ADDENDUM NO. 002

RE: Riner Rescue Squad Renovations
for the Montgomery County Board of Supervisors
T&L Project N. 13270-50

DATE: November 14, 2019

Sheet No.
P102

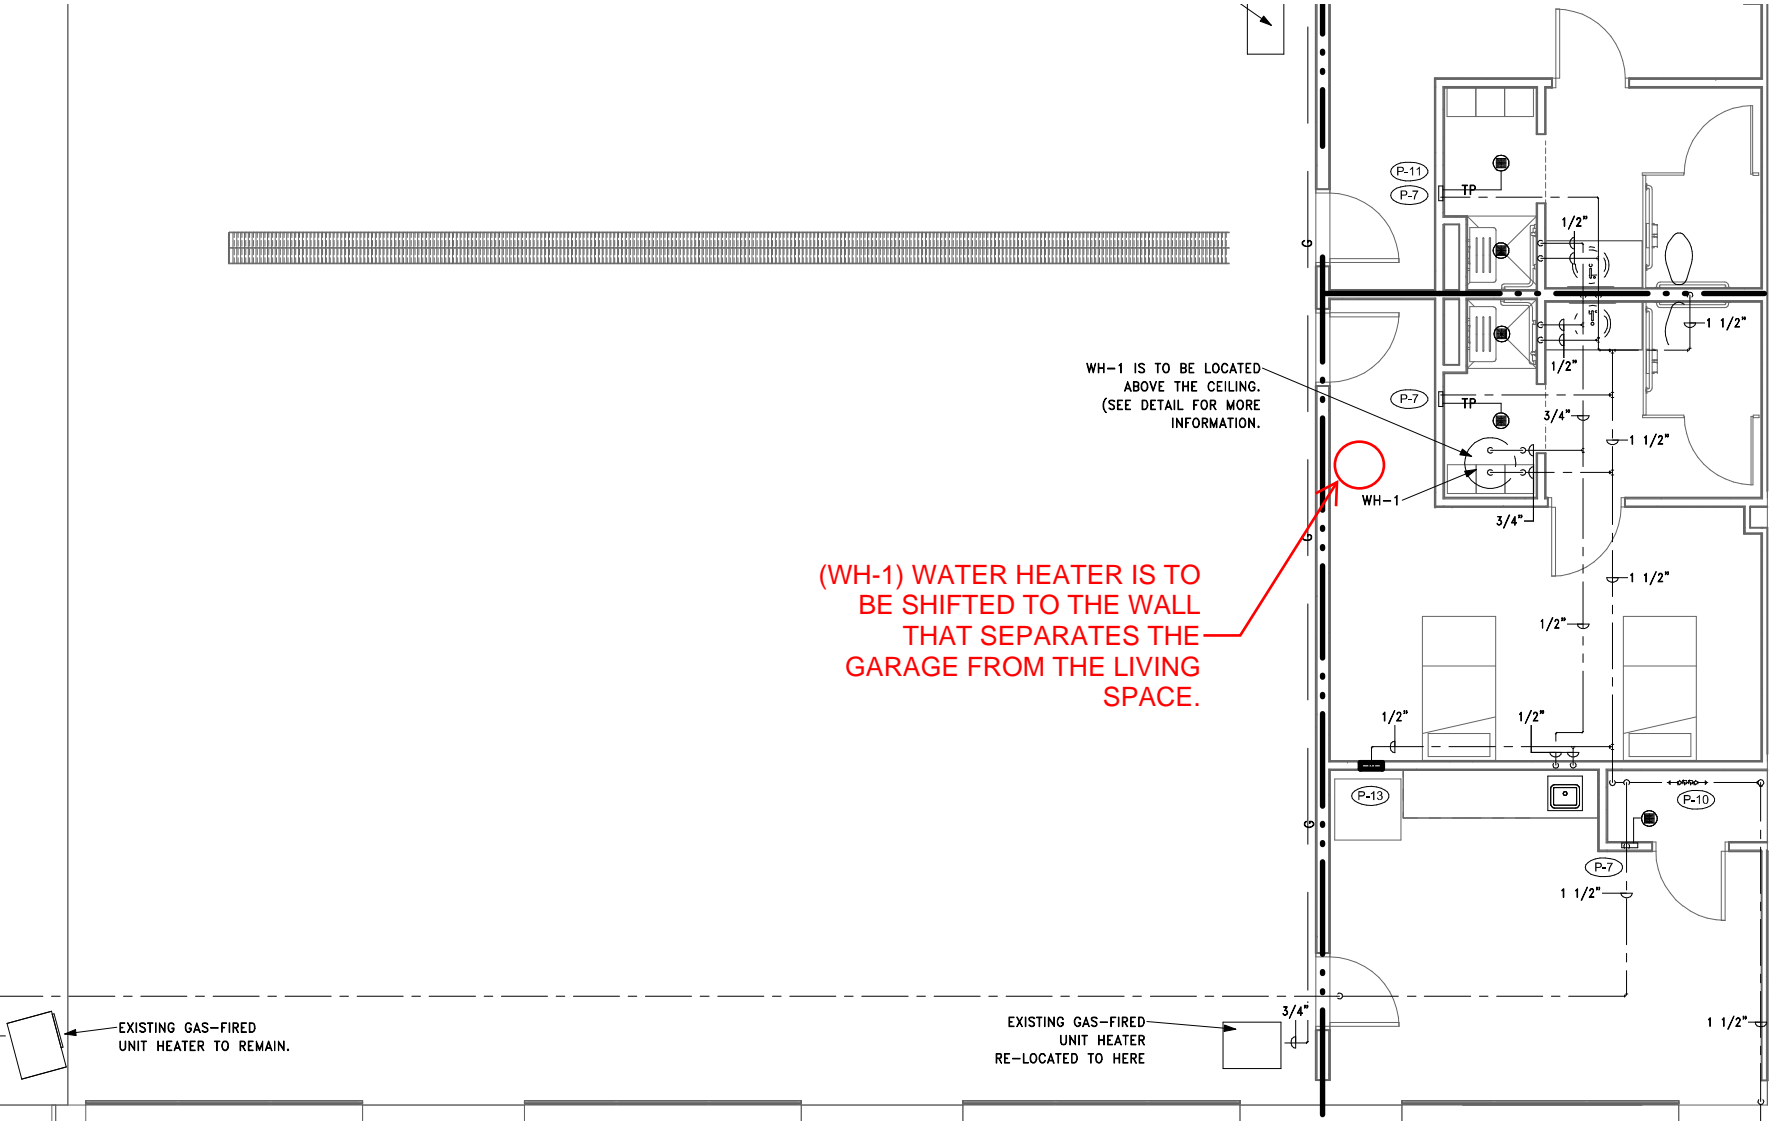
Contractor is to shift the location of the proposed water heater from the ceiling over the bathroom to above the ceiling along the 2-hour fire rated wall. This wall separates the garage area from the bunk rooms 118. This wall goes all the way to the structure. Set the elevation of the water heater to ensure positive gravity drainage. This pipe is to drain to the floor drain in Mech 120. Contractor is to coordinate the relocation of the power for the water heater with the electrical contractor. See enclosed excerpt from Sheet P102.

WH-1 IS TO BE LOCATED ABOVE THE CEILING. (SEE DETAIL FOR MORE INFORMATION.)

(WH-1) WATER HEATER IS TO BE SHIFTED TO THE WALL THAT SEPARATES THE GARAGE FROM THE LIVING SPACE.
